971 Runyon Road
Proposed Renovation

Stoney Creek Historic District

REVISED PROPOSAL

Submitted 6/4/2008

SCALE: 1/4"=1'-0"

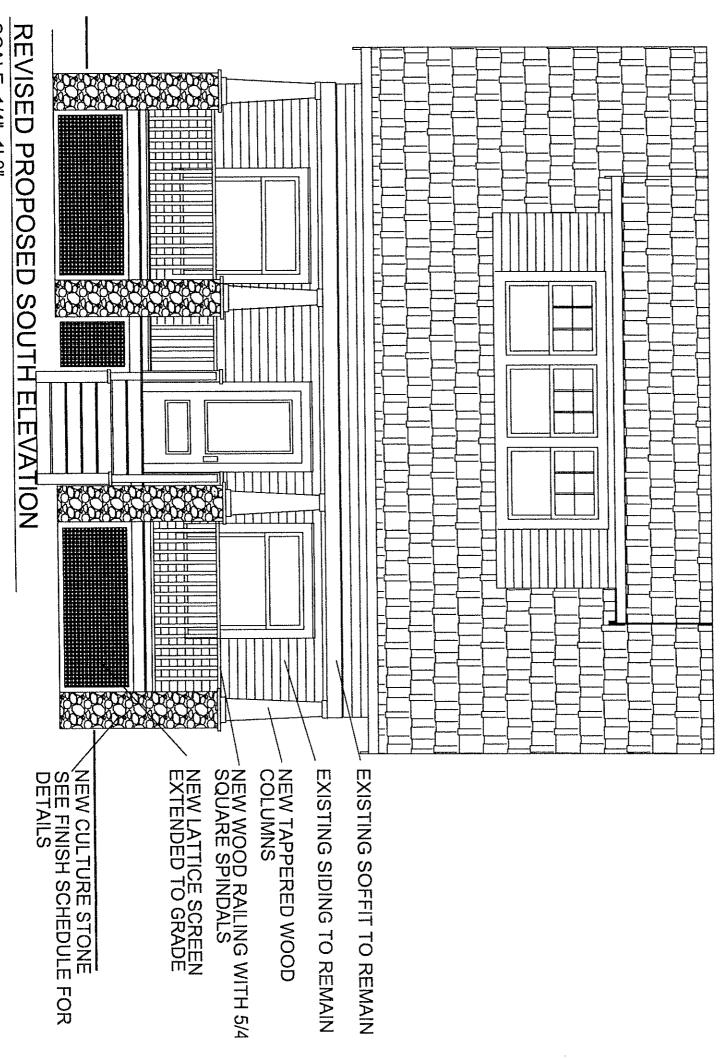
The deviation from the original submittal will be limited to the detail of the columns. The following changes are the reason for resubmitting:

- The column bases will be 18" wide and finished with StoneCraft manufactured stone "River Rock" that will match the exposed foundation of the original house. As seen in the revised drawings the stone will extend from the ground to a height 3'-0" above the porch floor.
- Tapered wood columns will be added from the top of the stone to the underside of the existing wood soffit that will remain.

The proposed deviation is sensitive to the style and period of the house. Tapered columns and the use of native stone can be found throughout our community. By utilizing an alternative to wood as the base of the columns wood rot that had caused the structural issues with the porch will be eliminated.
